City of Fredericksburg

Planning and Zoning Meeting Agenda
Wednesday, January 3, 2024 ~ 5:30 PM
Law Enforcement Center
1601 E. Main Street
Fredericksburg, Texas 78624

Re: : Chick-fil-A Fredericksburg – Preliminary Plat and CUP/Site Plan Review

The following is our comment response letter addressing comments received from the Development Review Committee, dated November 13, 2023. Our response to each comment is as follows:

P-2330

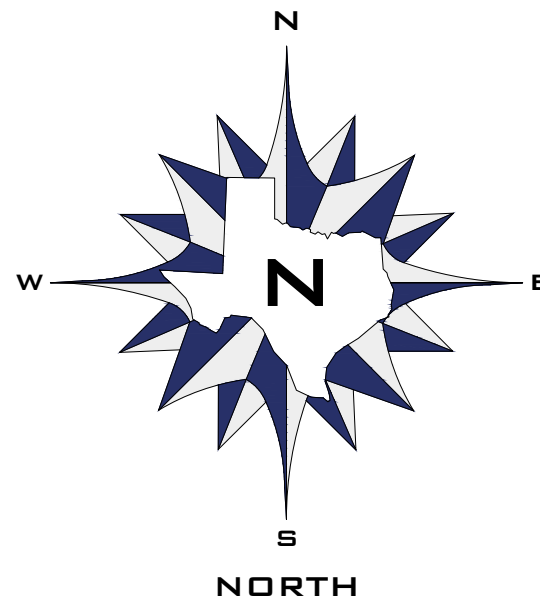
Comment 1: Provide addresses for Lots 1AR-1, 1AR-2, 1AR-3.

Comment 2: Add Project Number, P-2330, to Plat.

Comment 3: A Parkland dedication fee of \$500.00 per lot for a total of \$500.00 must be paid prior to recordation of the plat. Sec. 6.15 – Subdivision Ordinance.

Comment 5: Show any proposed drainage easements across the proposed lots if necessary for conveyance of stormwater.

Response: Addresses provided by City are now listed for each lot.

Response: City project number has been added.

Response: Noted – this will be paid following approval and prior to recording.

Response: Drainage easement is provided along the eastern boundary of Lot 2 for the benefit of Lot 3.

SITE PLAN

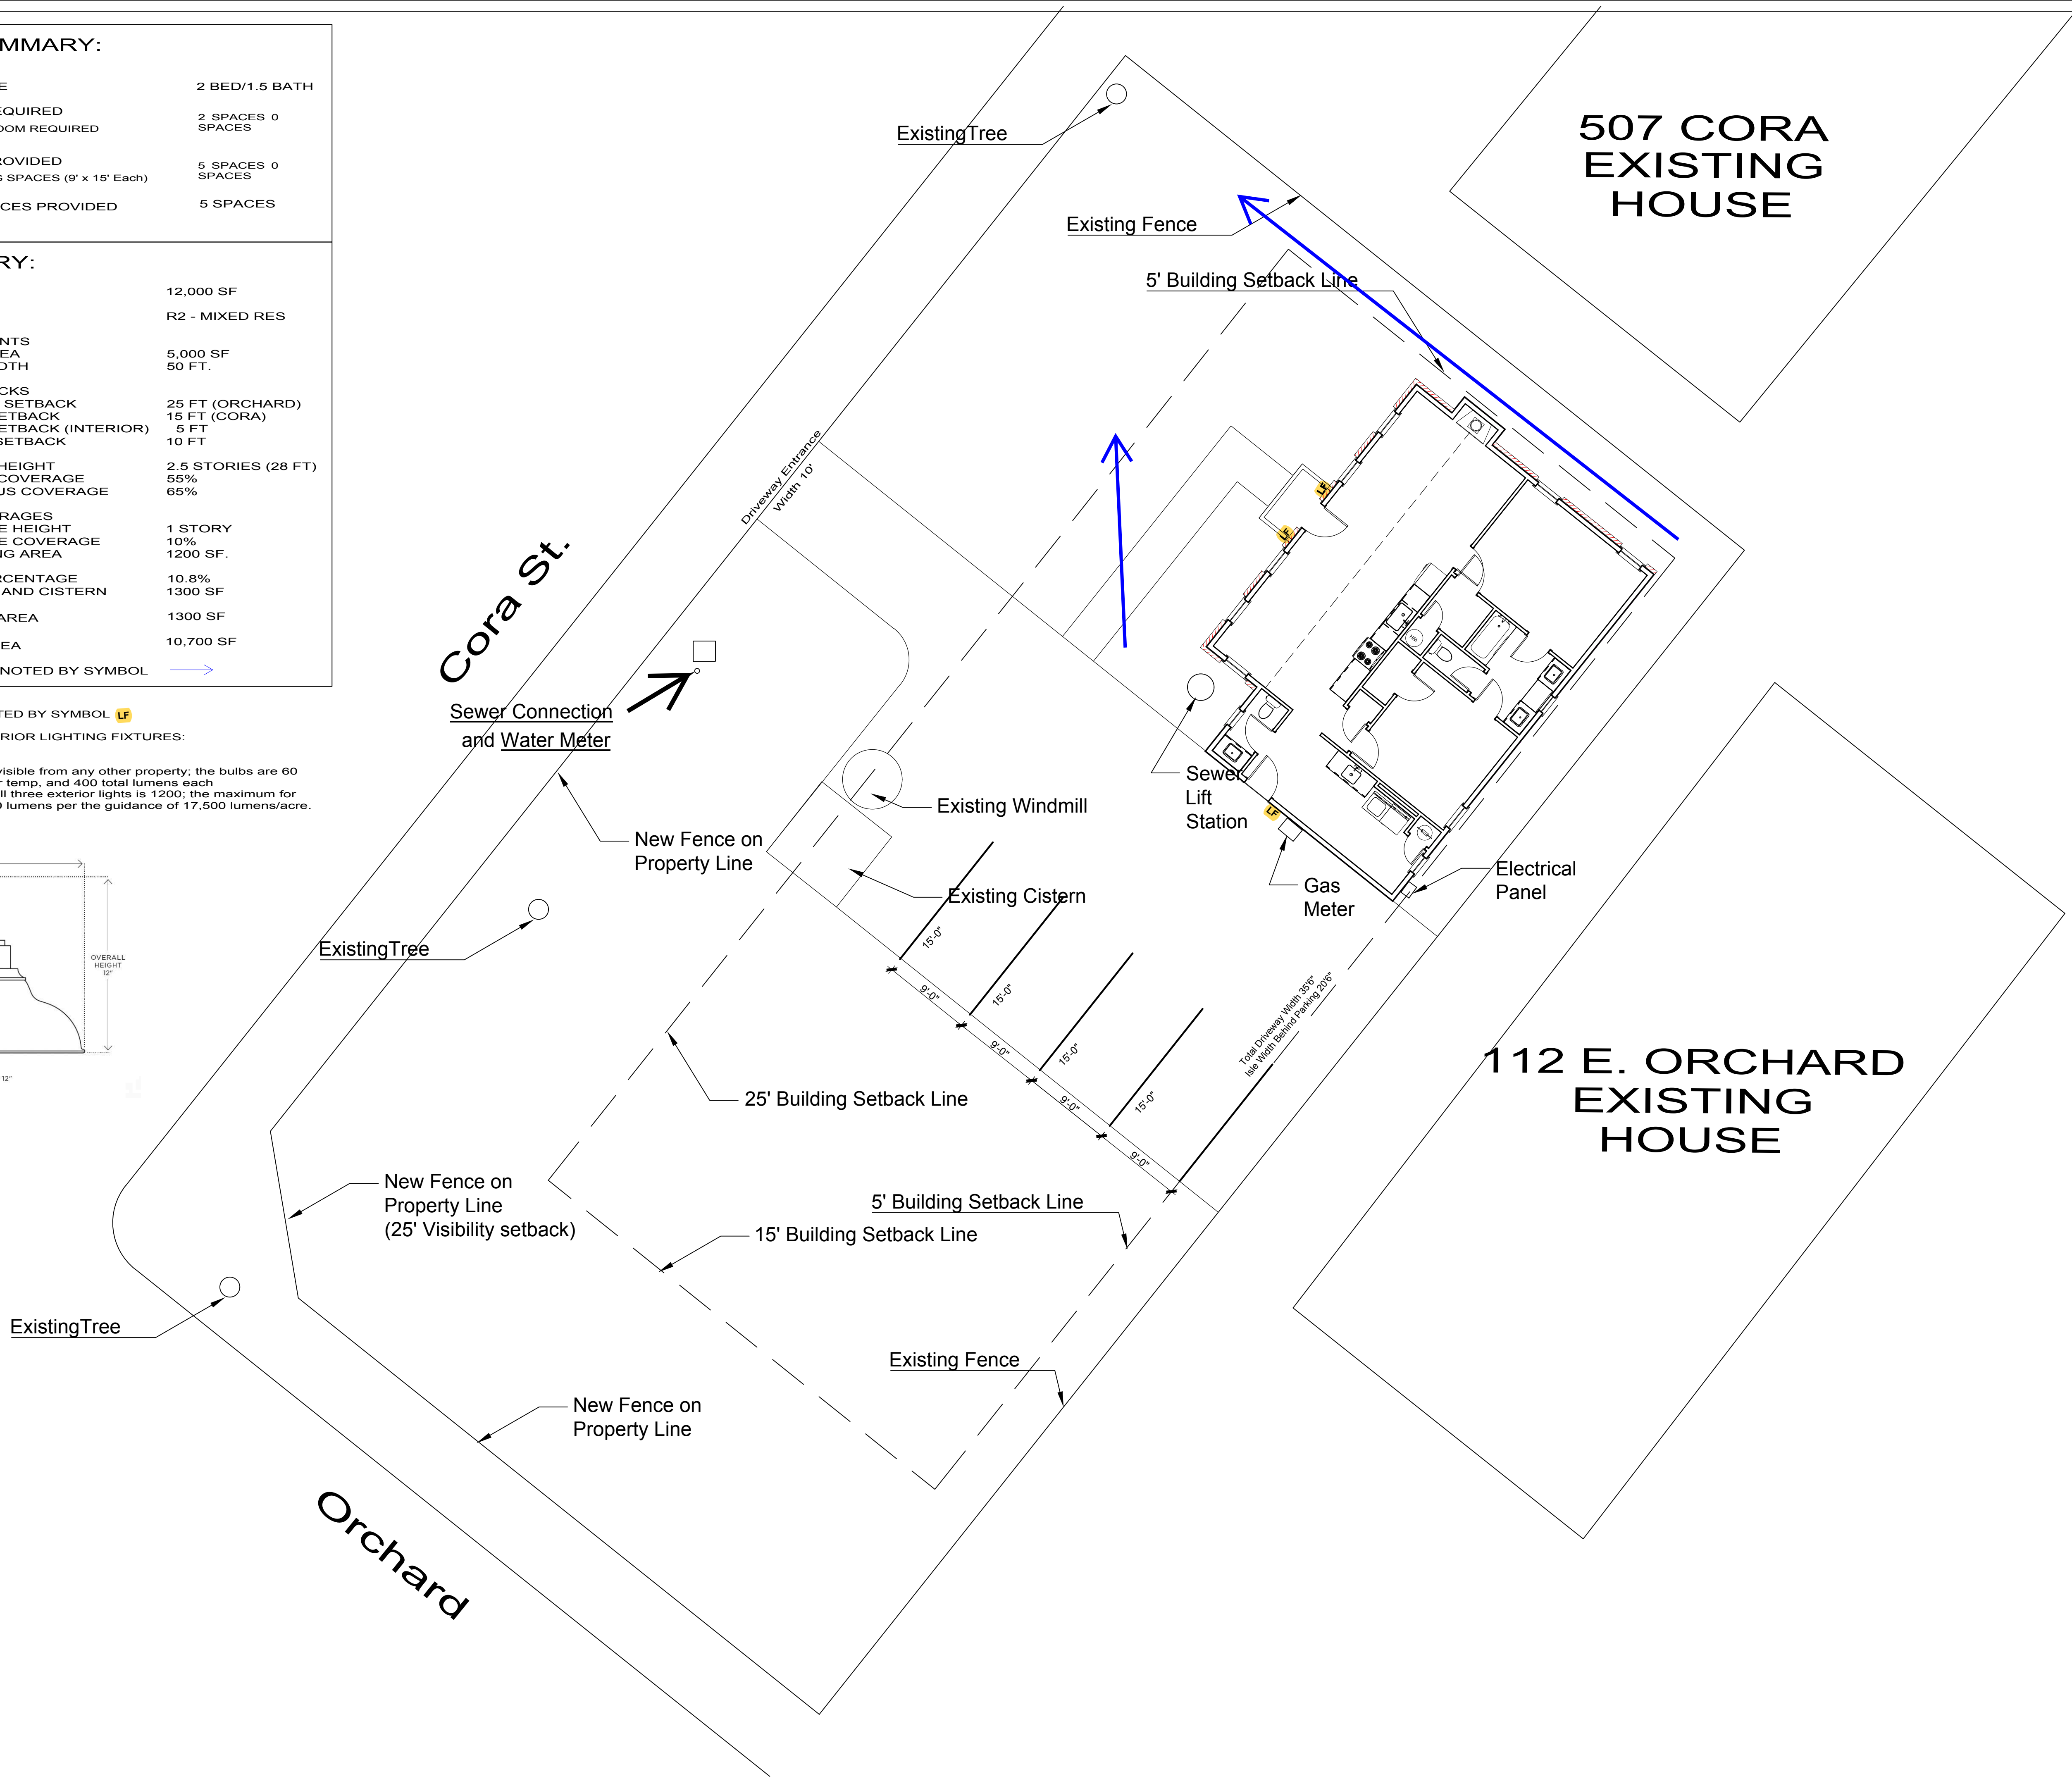
- Please update the site plan with the property dimensioned parking spaces. 18.5 x 9. [Sec. 7.863](#) Dimension depth of parking spaces. Dimension width of isle behind parking spaces.

SITE PLAN

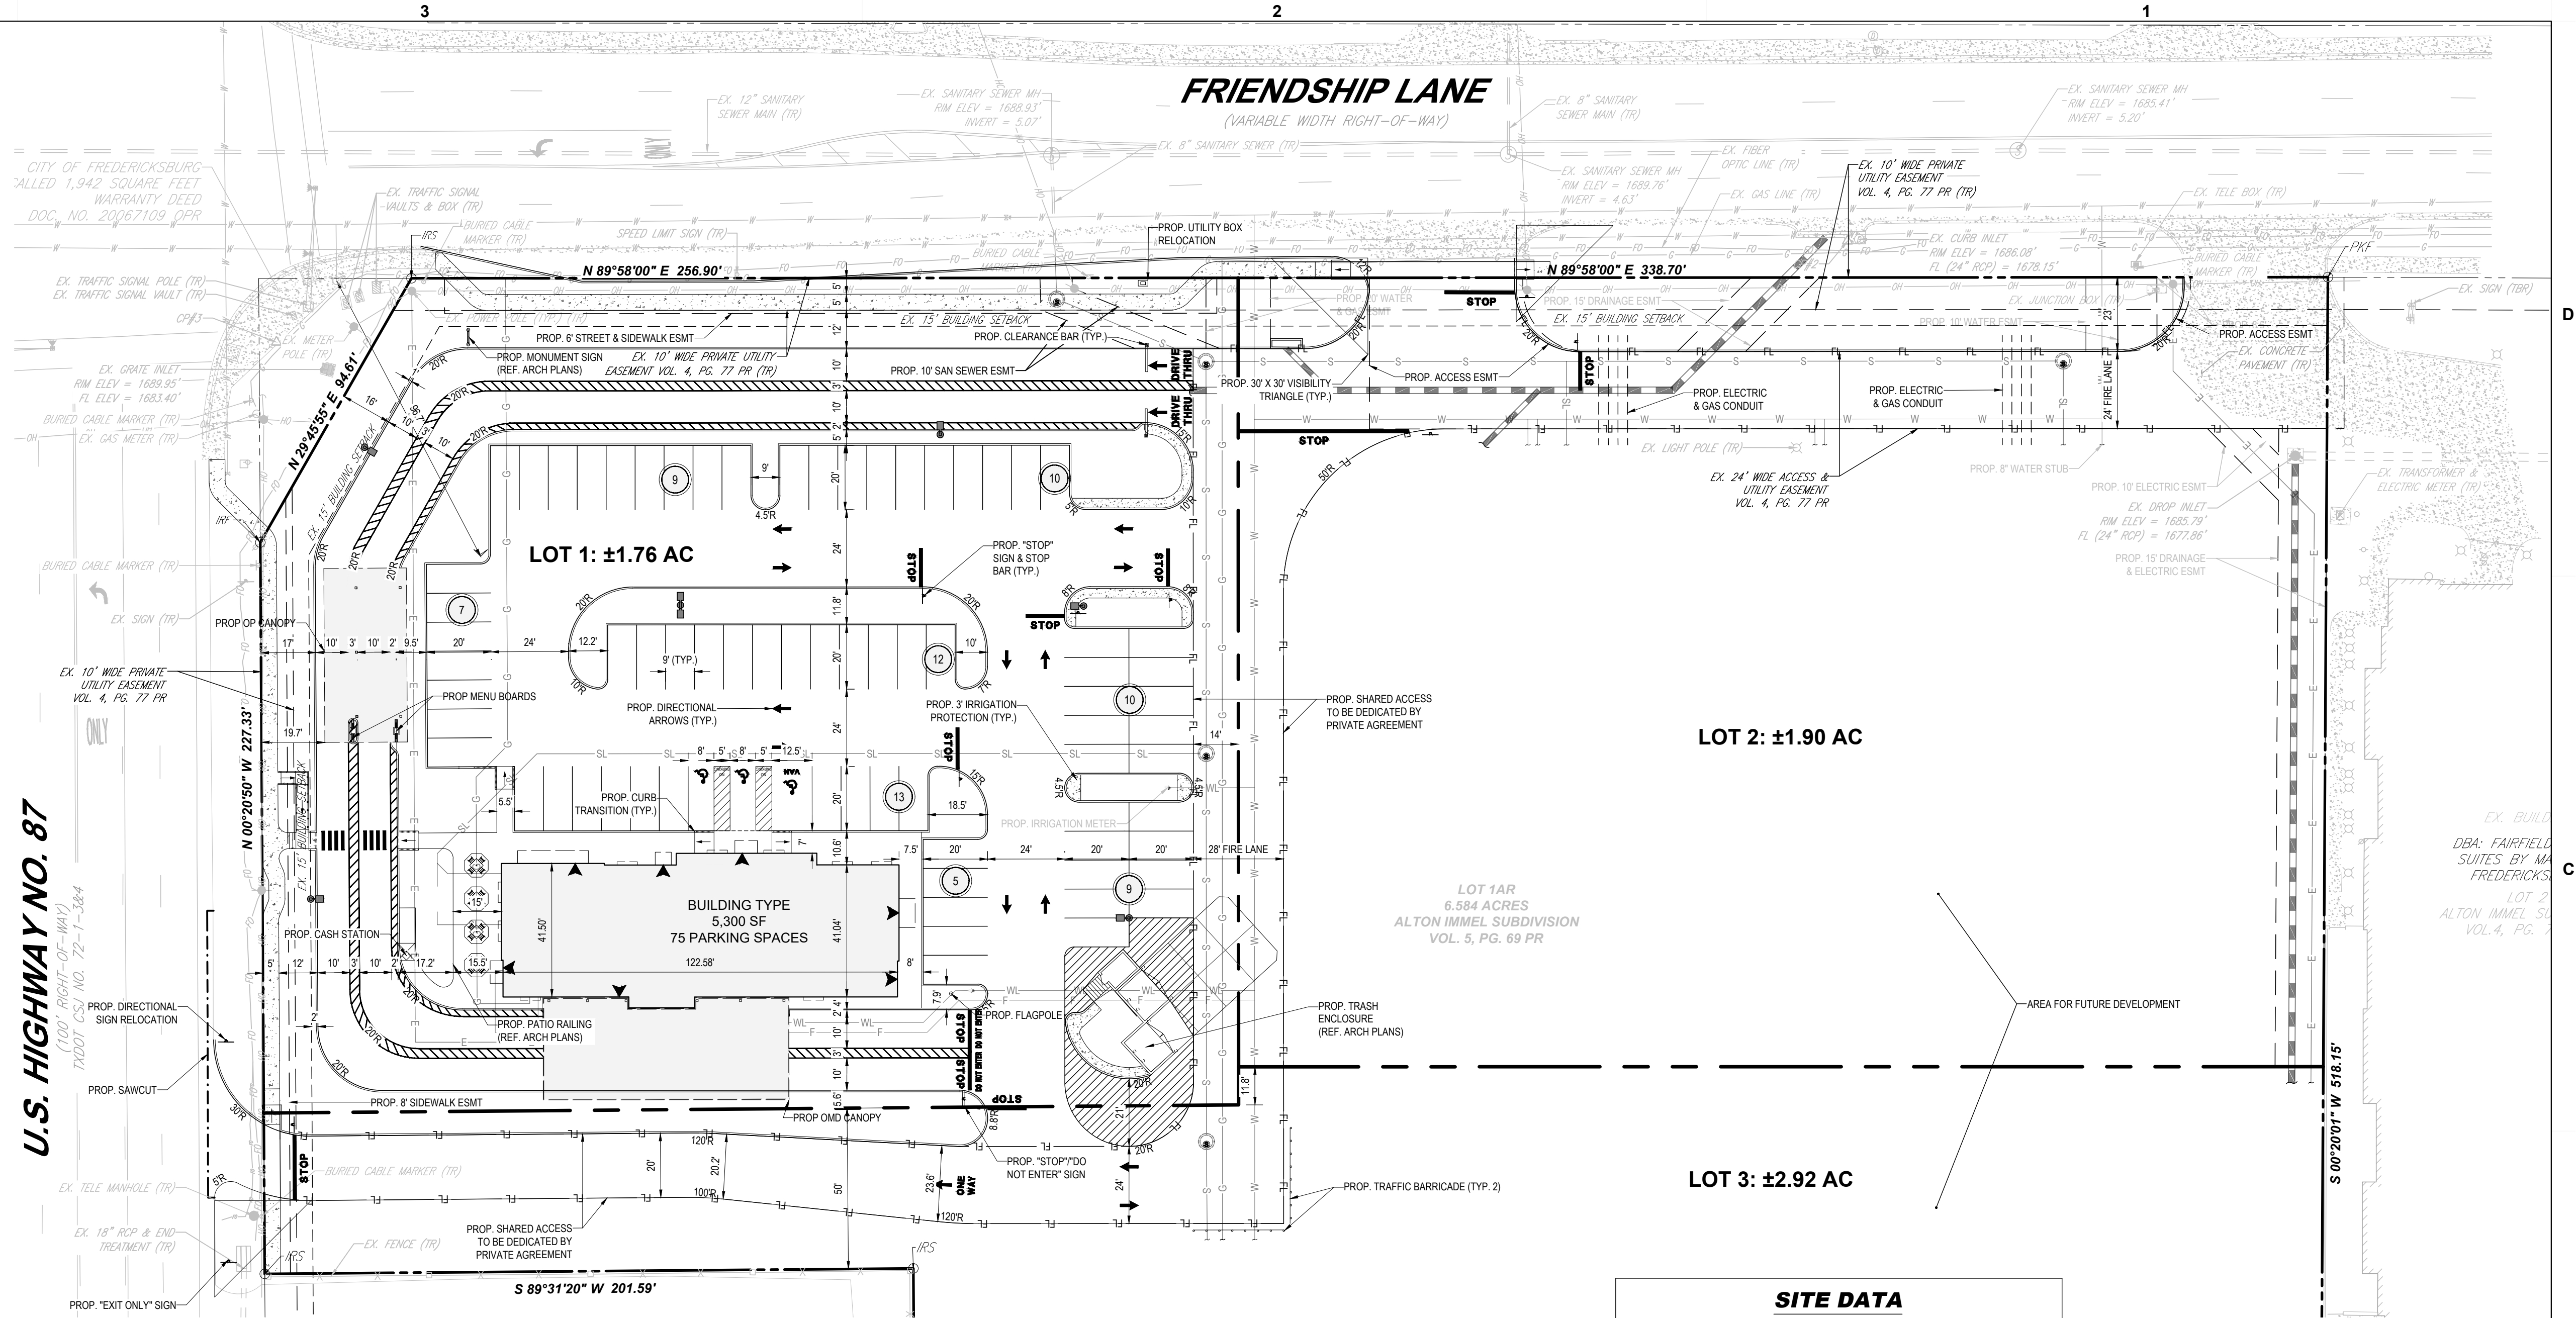
Comment 4: The arrangement of the facility, specifically the drive-through against the street frontage, is not ideal. Show typical car “stacking” in the drive-thru aisles. Sec. 7.131 Site Plan Checklist

Comment 19: Show visibility triangles at each driveway.

Comment 20: Construct sidewalk along public street frontage. Provide an ADA route from the public sidewalk to the building.

Response: Code section and checklist provided do not require car stacking to be shown in the drive-thru. Stacking provided for this user is adequate based on other locations in this area. Location of drive-thru is strategic to provide ample stacking to where drive-thru stacking does not affect street traffic.

Response: Visibility triangles are shown on the site plan and plat both. No northern triangle is shown on the Hwy 87 access as it is right out only.

Response: Connectivity to public sidewalk is provided.
